ADDENDUM NUMBER FOUR

**DISTRICT FIVE OF
LEXINGTON & RICHLAND COUNTIES
CHAPIN ELEMENTARY SCHOOL**

**CALLOWAY JOHNSON MOORE WEST (CJMW)
201 WEST MAIN STREET
LEXINGTON, SOUTH CAROLINA 29072**

DATE OF ISSUE: April 9, 2009

PORTION OF
DRAWING C2

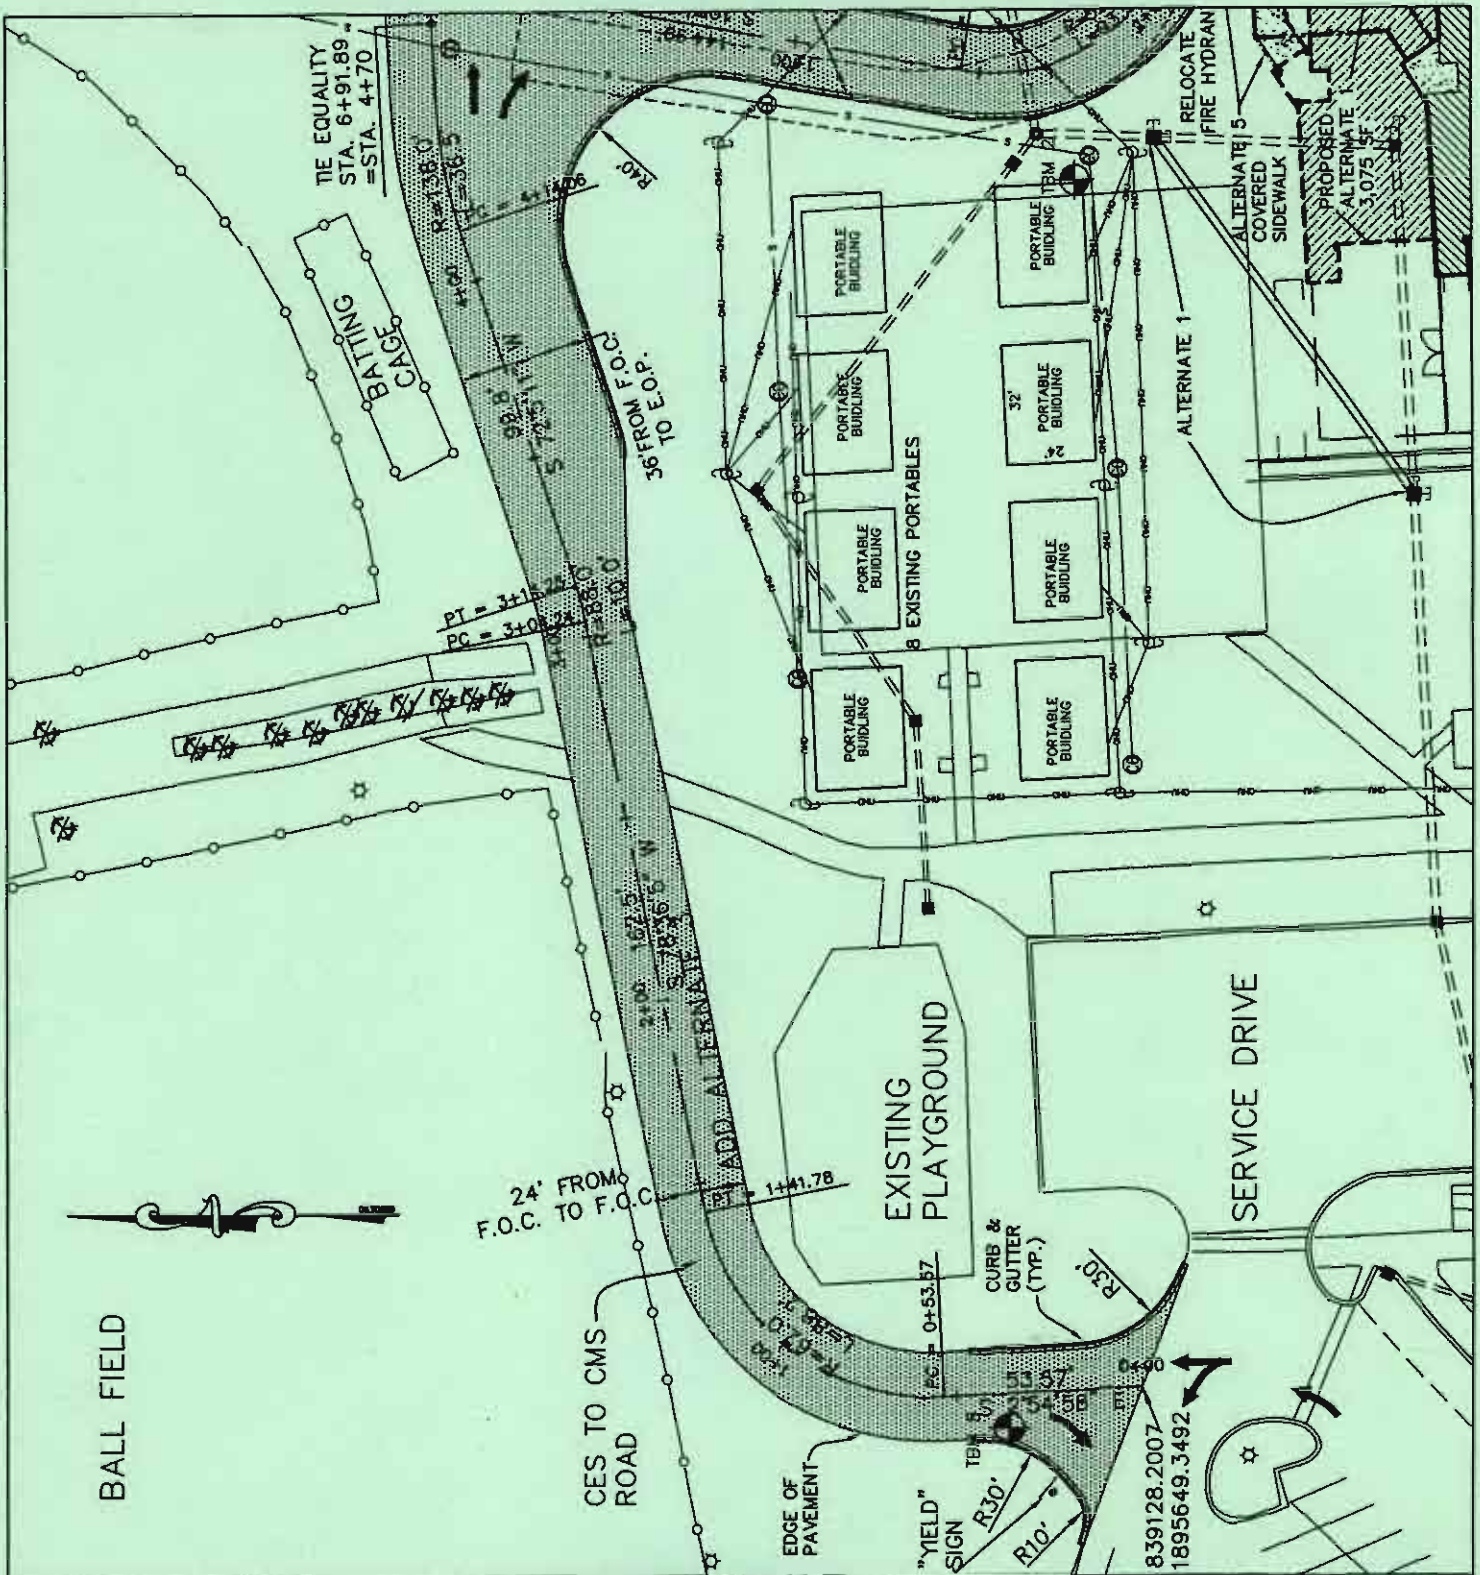
7. **Drawing Sheet C2:**
Change the asphalt and curb and gutter to be removed in the north end of the "Faculty Parking", delete the removal and relocation of fence from the Ball Field, and delete the notes and hatching calling for removal of the batting cage, sidewalks, trees, and light pole as shown in the attached 8 ½ x 11 copy of a portion of the drawing. Add the removal of a portion of sidewalk as shown. (See Attached Sketch BDC001)

PORTION OF DRAWING C3

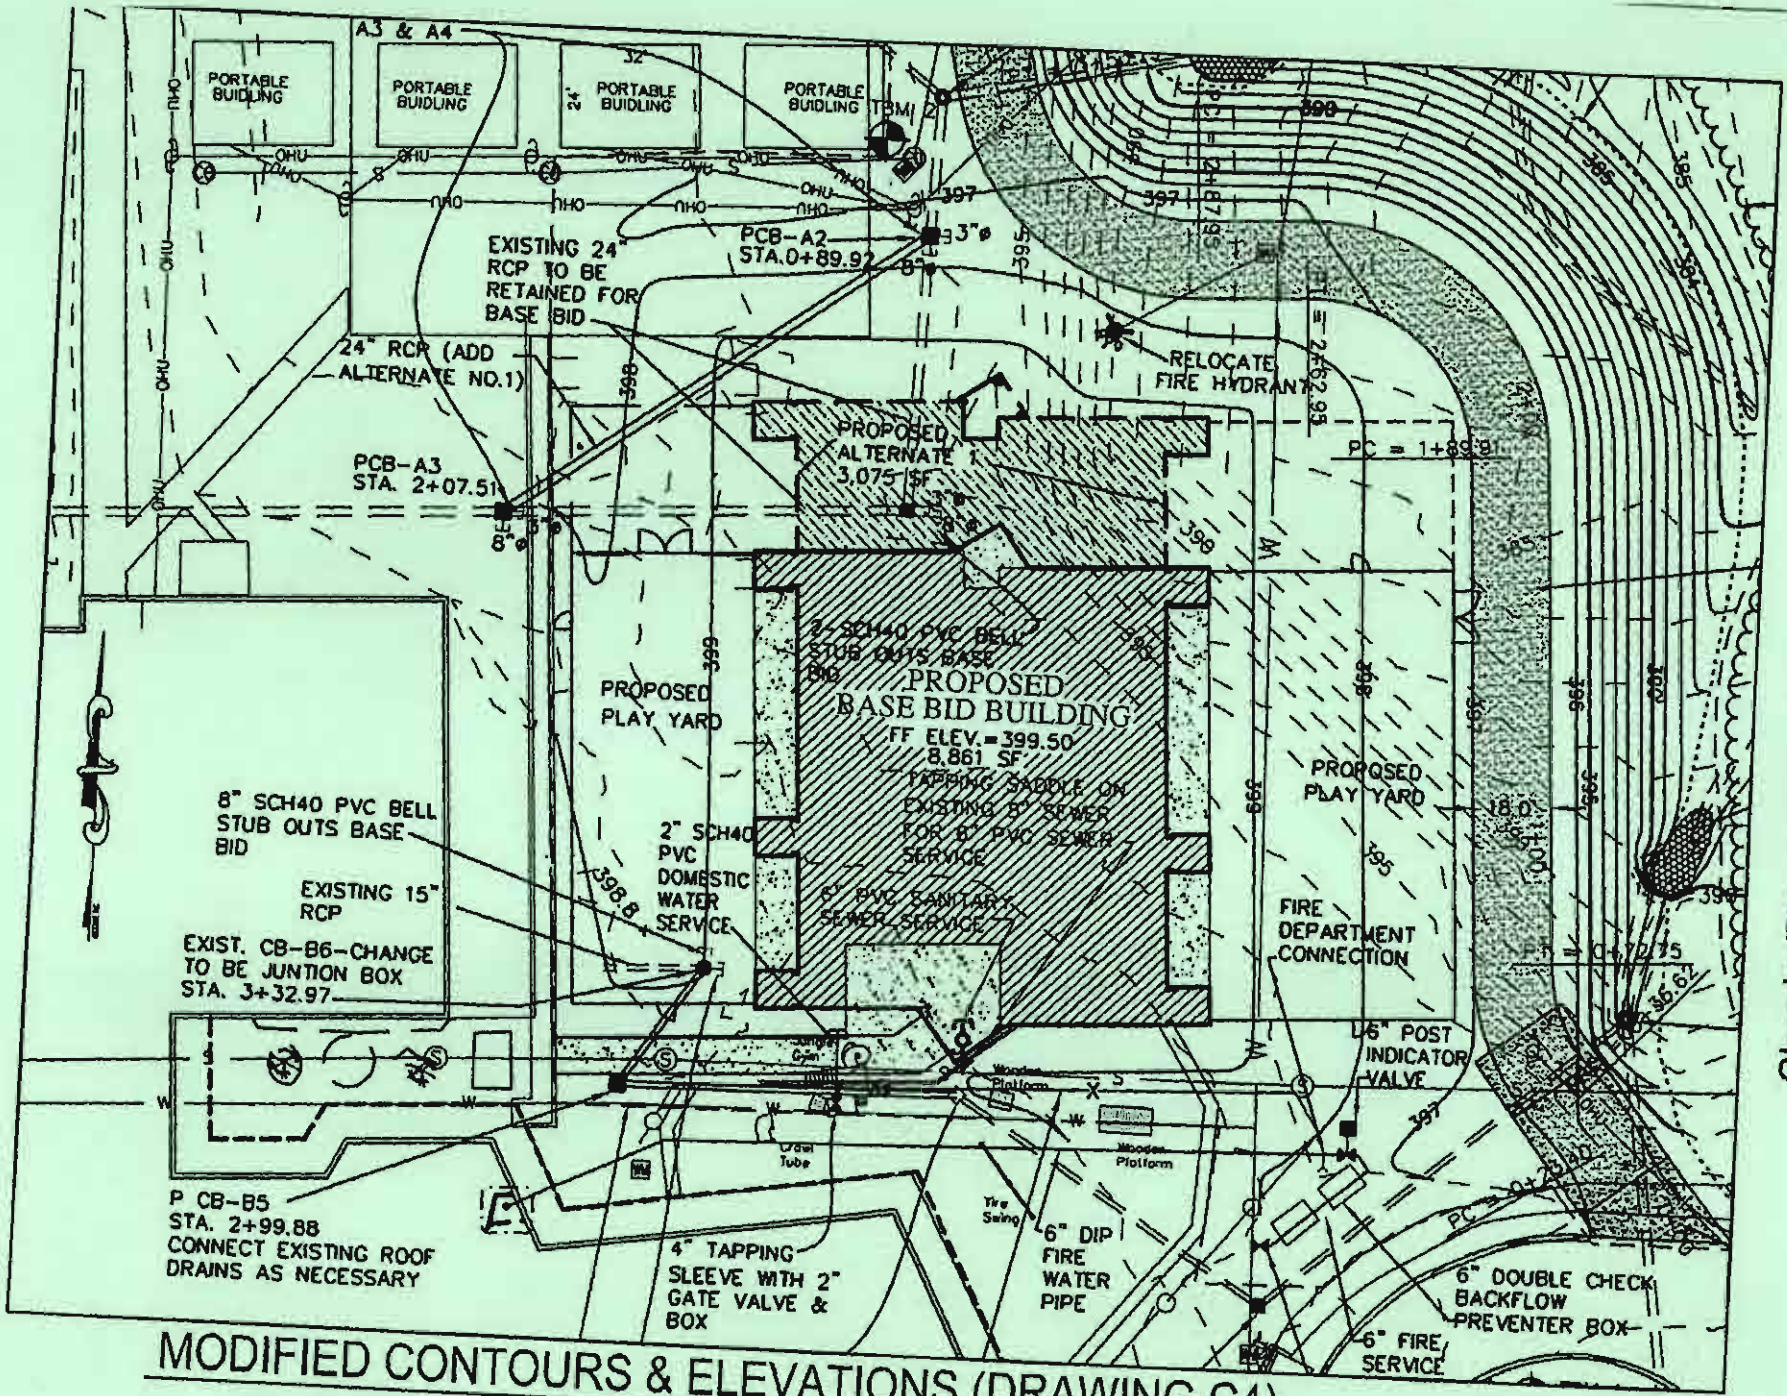
8. **Drawing Sheet C3:**
Change the "CES to CMS Road" from Station 0+00 to Station 6+91.89 to be as shown in the attached 8 ½ x 11 copy of a portion of the drawing. Take note of the station equality so that Station 4+70 of the new alignment equals Station 6+91.89 of the original alignment. (See Attached Sketch BDC002)

MODIFIED CONTOURS & ELEVATIONS (DRAWING C4)

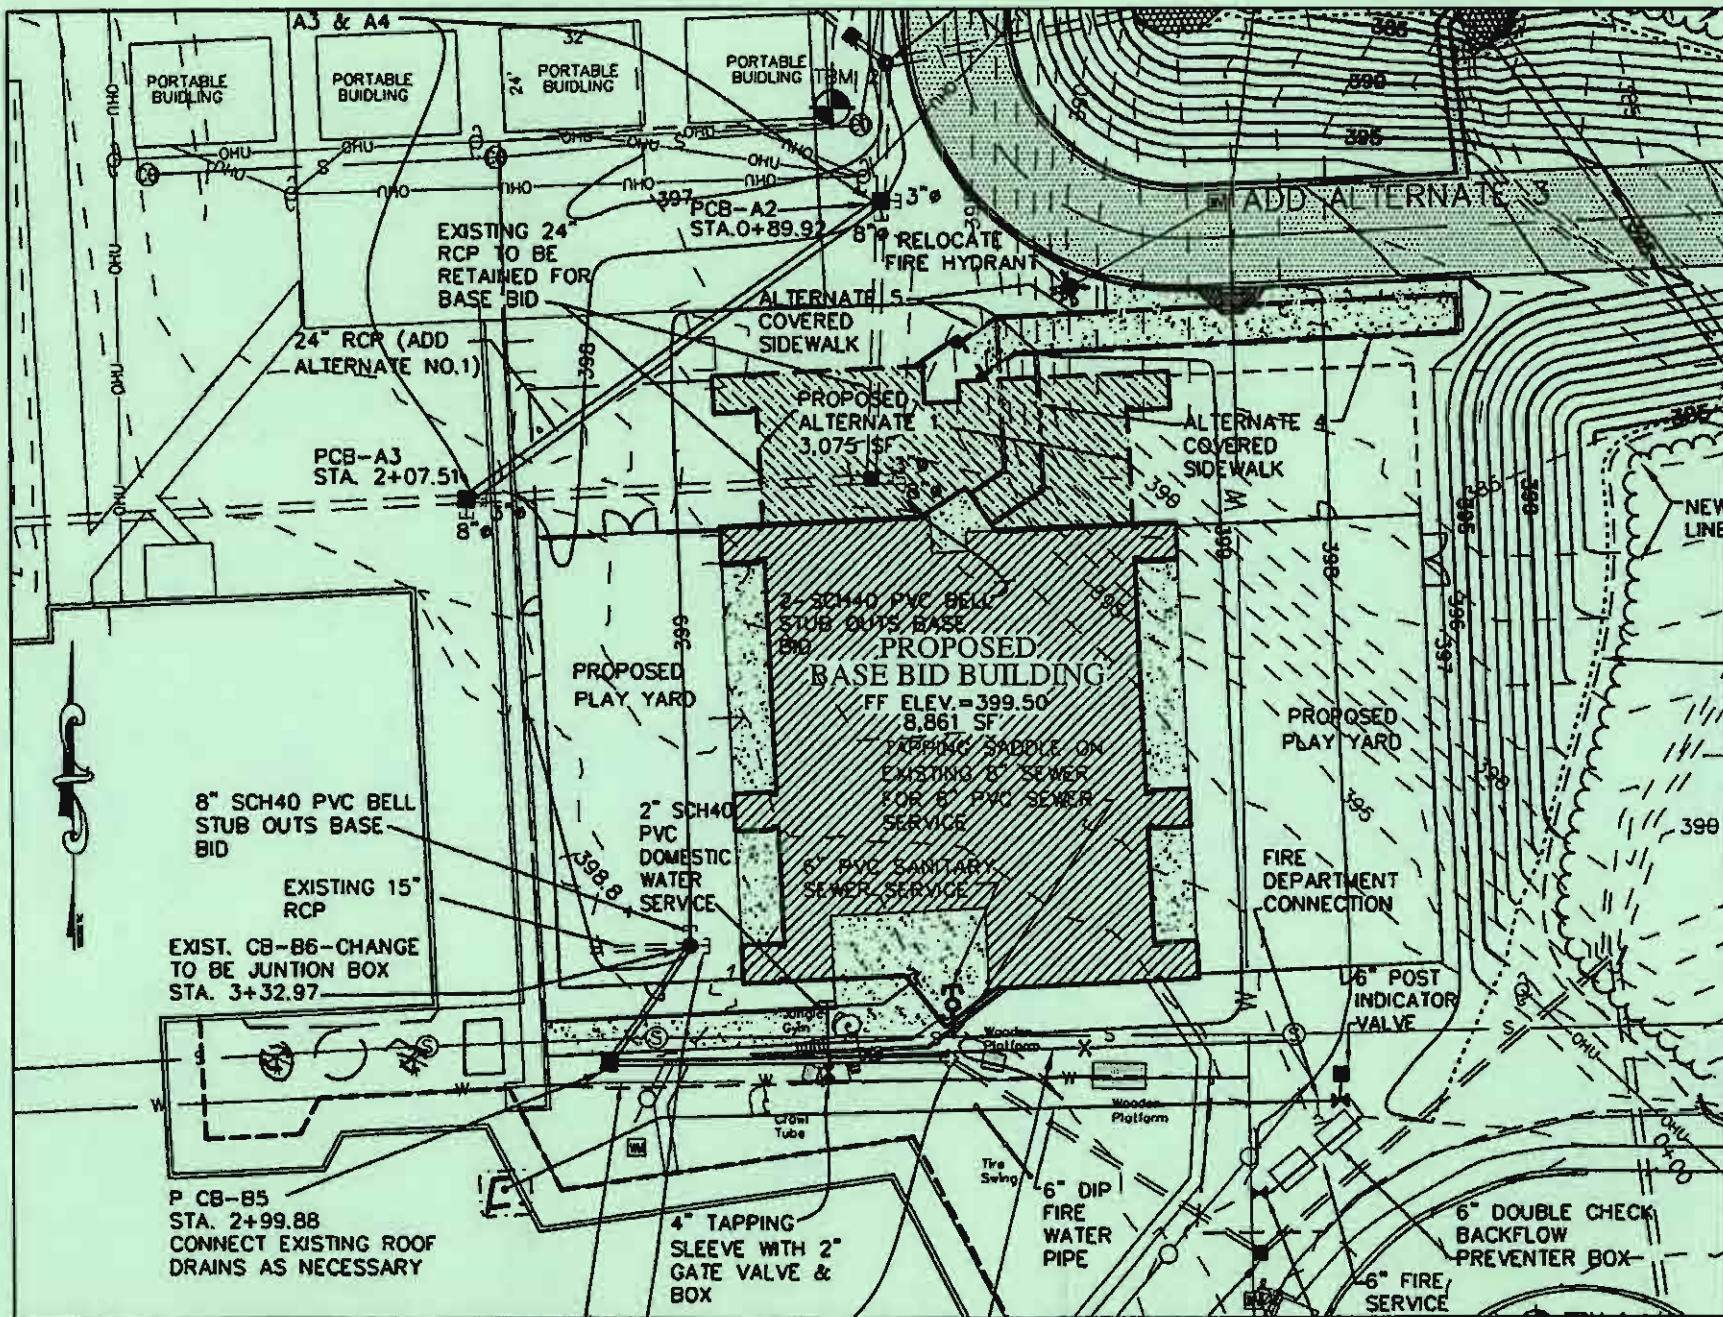
9. **Drawing Sheets C4 & C5:**
Modify the proposed contours between the side of the proposed Kindergarten Building and the existing building and add the spot elevation as shown on the attached Sketches BDC003 and BDC004.

PORTION OF
DRAWING C5

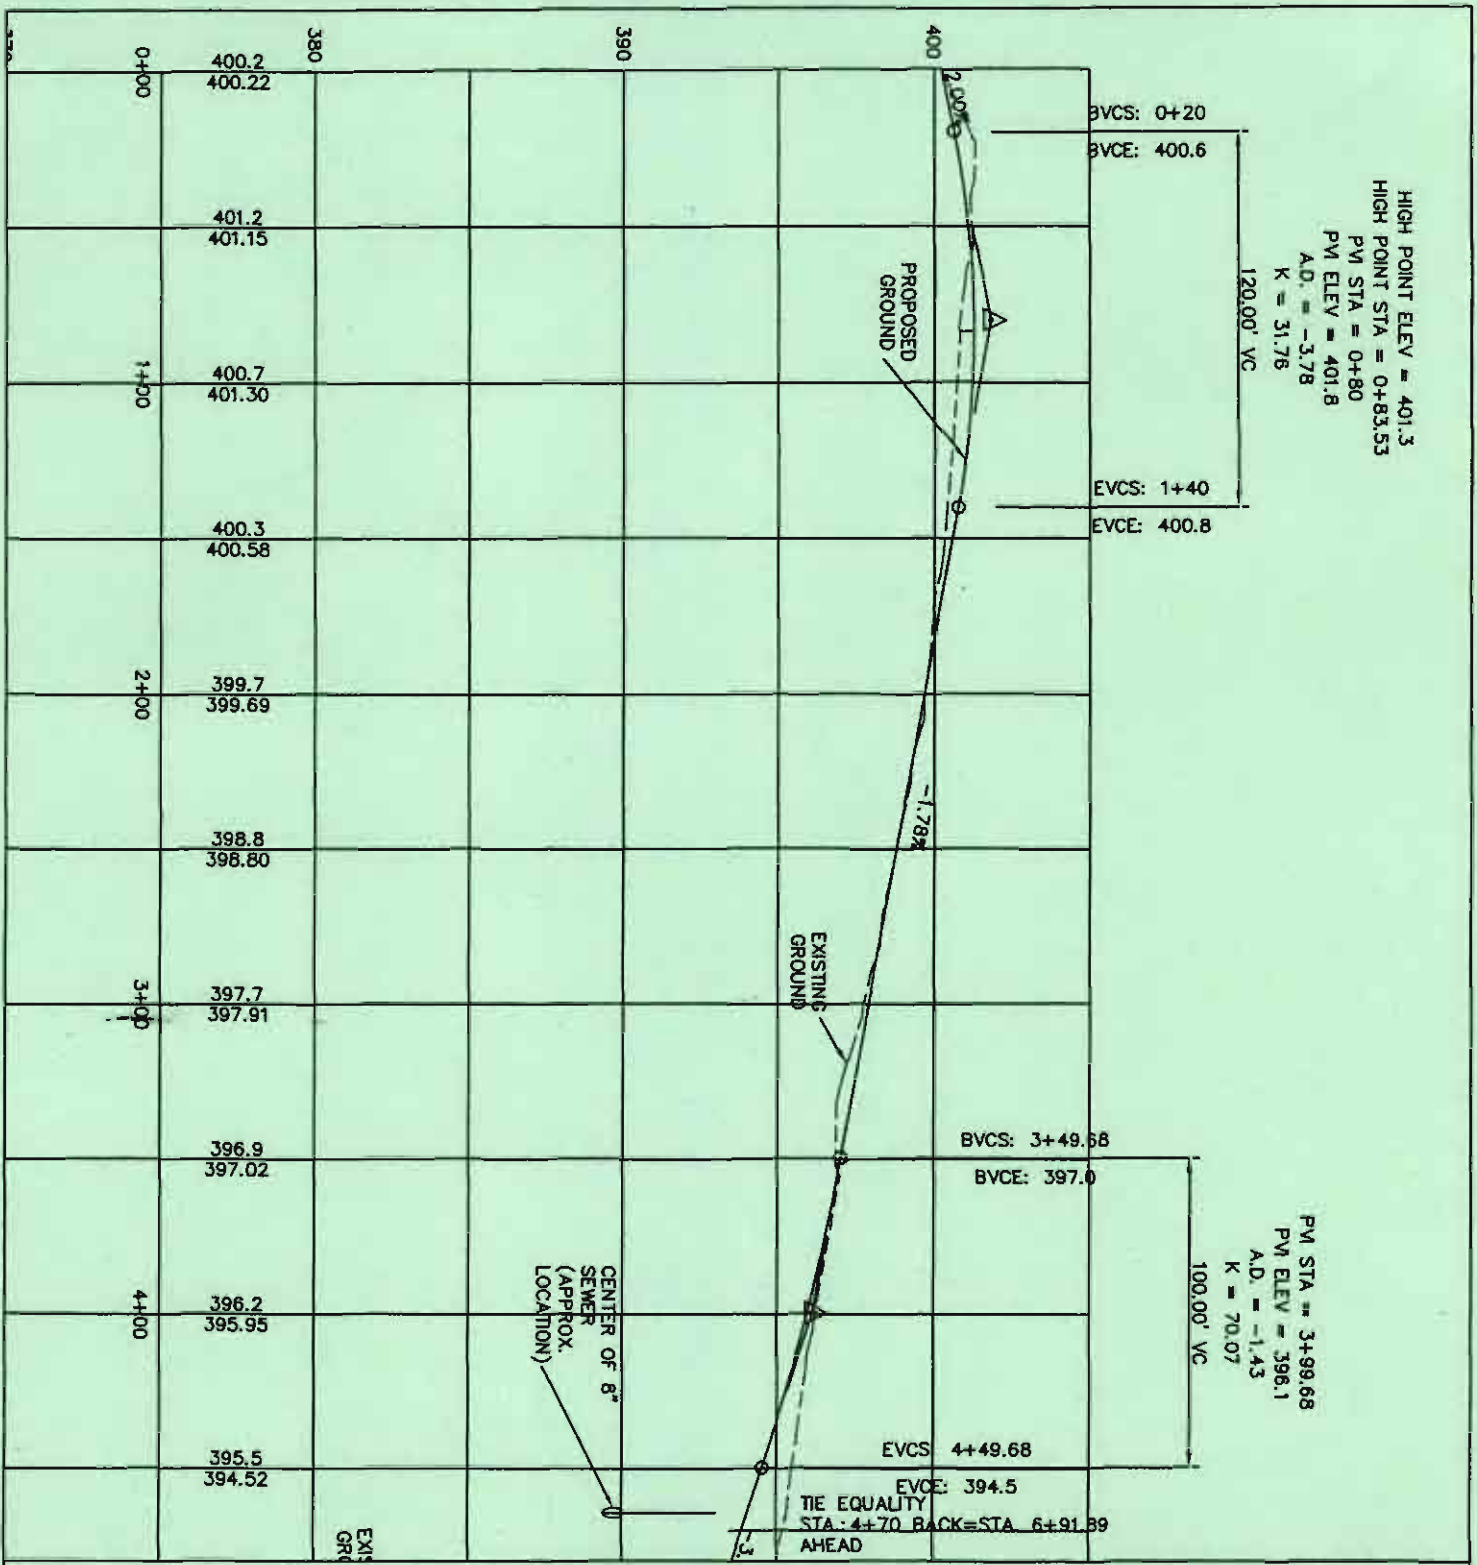
11. **Drawing C5:**
Change the "CES to CMS Road" from Station 0+00 to Station 6+91.89 to be as shown in the attached 8 ½ x 11 copy of a portion of the drawing. (See Attached Sketch BDC005)

PORTION OF
 DRAWING C6

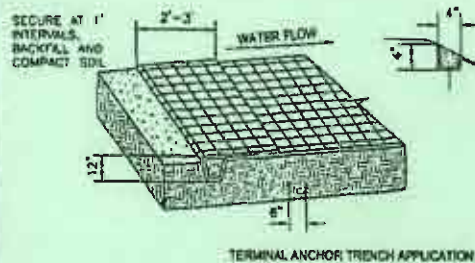
12. **Drawing C6:**
Change the "CES to CMS Road Profile" from Station 0+00 to Station 6+91.89 to be as shown in the attached 8 ½ x 11 copy of a portion of the drawing. Take note of the station equality given as "Tie Equality Station 4+70 Back = Station 6+91.89 Ahead. Contractor shall use the attached profile from Station 0+00 to Station 4+70 and the original profile from Station 6+91.89 to the end of the road. (See Attached Sketch BDC006)
